## Duquesne Light

SUBJECT: Beaver Valley Power Station - Unit No. 2  
Docket No. 50-412  
NRC Structural Design Audit

## NRC STRUCTURAL AUDIT ACTION ITEMS

Figure 7.1  
 Three-Step Soil-Structure  
 Interaction Solution  
 Beaver Valley Power Station  
 Unit 2

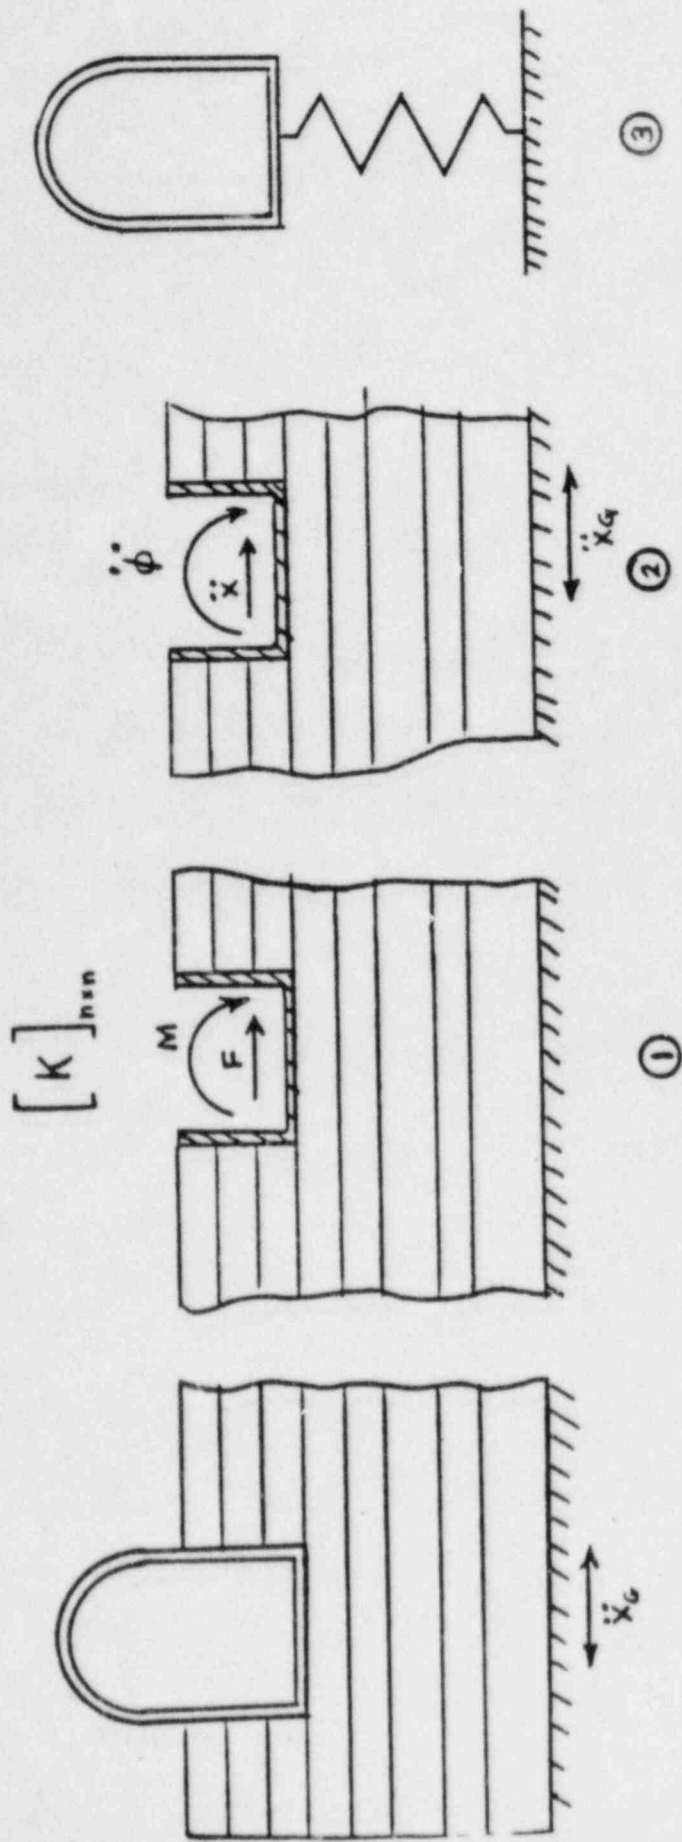
7. Perform soil-structure interaction analyses for the two key structures (containment and intake structure) to show that the intent of SRP 3.7.2.II.4 is met. Where discrepancies from the SRP are identified, provide a justification by accounting for as-built strength of materials and design conservatisms. Also, compute for the intake structure applicable safety factors against sliding and overturning based on the revised analyses and show conformance to the criteria of SRP Section 3.8.5.

These steps are presented on Figure 7.1.

In the second step of the analysis shown on Figure 7.1, the purely translational input ground motion specified at the surface of the stratum is transformed into both a translational and rotational motion at the base of the rigid, massless foundation. In a stratum undergoing translational motion only, the boundary conditions at the "excavation" require the foundation to rotate.

The third step of the procedure is the analysis of the structural model supported on the frequency-dependent soil spring from Step 1 for the modified seismic input motion from Step 2. The solution is achieved using the computer program FRIDAY. FRIDAY solves the equations of motion in the frequency domain, determining response time histories by convolution of the transfer functions and the Fourier transform of the input excitation.

Figure 10.1

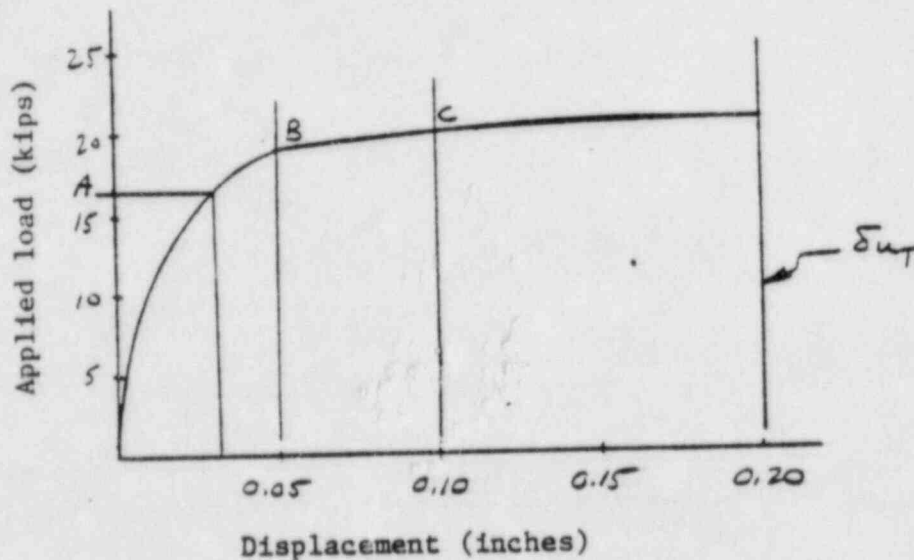
CC-3730 (b) The allowable force and  
displacement capacities of liner  
anchors are given in Table CC-3730-1.  
These values are listed in Attach-  
ment 10.3.

BVPS-2 allowable design loads are greater than the Division 2 allowables. As shown on Figures 10.1 and 10.2 there is adequate margin between the BVPS-2 allowable design loads and the ultimate failure capacity of the anchor. The BVPS-2 values result in a factor of safety of 3 for tension and 10 for shear when comparing the displacement at the allowable design load to the anchor's ultimate displacement (based on the Nelson Stud).

Figure 19.1  
Typical Cross-Section of  
Buried Conduit Duct Bank  
Beaver Valley Power Station  
Unit 2

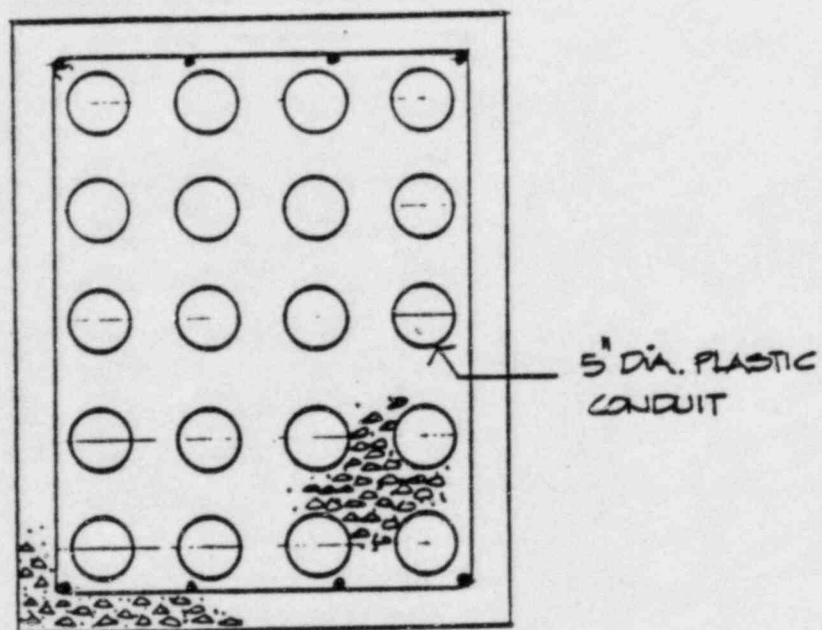
19. With respect to Category I duct banks, describe the design criteria and analysis procedures used to demonstrate the adequacy, and also indicate if the applicable criteria of SRP Section 3.8.4 were met. For any deviations from the criteria identified, please provide a justification considering the as-built material strengths and conservatisms, as appropriate.

Condition (1) was assessed using well-known methodology such as that of Terzaghi (1955). The effect of the soil pressure on the structural integrity of the buried conduits at BVPS-2 is insignificant due to their cross-section configuration. A typical cross-section of a buried conduit duct bank is shown on Figure 19.1. The effect of conditions (2), (3), and (4) were established with an equivalent static analysis which considers the conduit duct bank as a beam element supported on an elastic foundation.

Figure 20.1

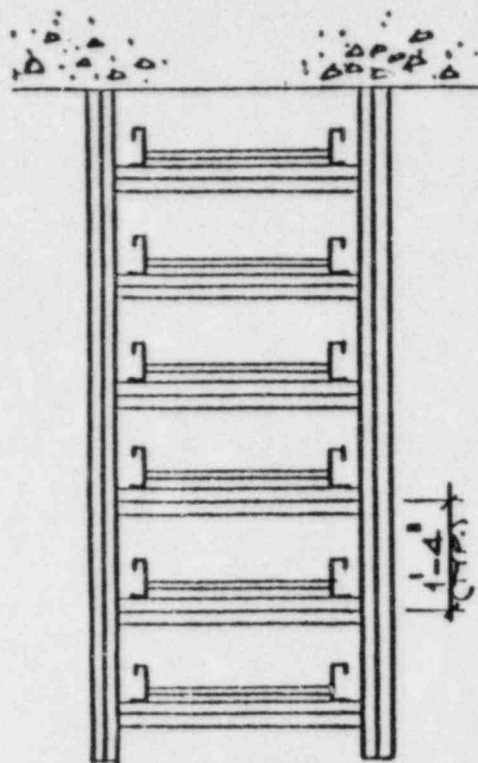
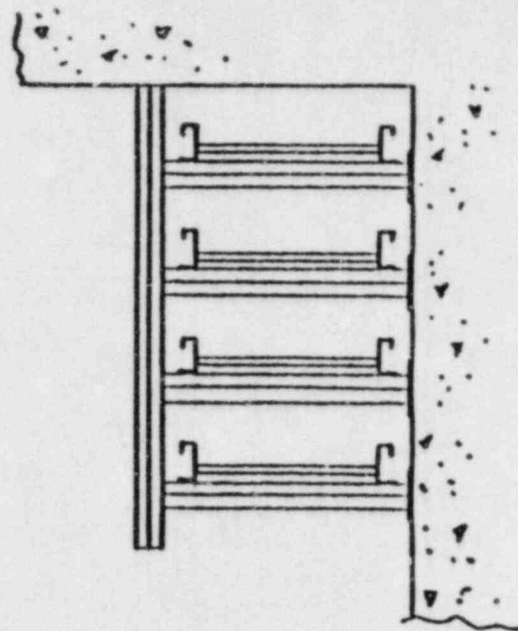
20. Describe the key types of cable tray (and conduit) configurations used at BVPS-2. For each of the configurations identified, evaluate if the criteria provided in SRP Section 3.8.4 were fully met in the design and analysis of the trays (and conduit). For any deviations from the criteria identified, please provide a justification considering the as-built material strength and conservatism, as appropriate. The selection of key types of cable trays should consider the various layers of decking as well as the variability in supports and anchoring effects.

The cable tray supports at BVPS-2 are of three basic types: trapeze, propped cantilever, and cantilever. An illustration of each type of support is shown on Figure 20.1. The standard vertical spacing between cable trays is 1'-4".
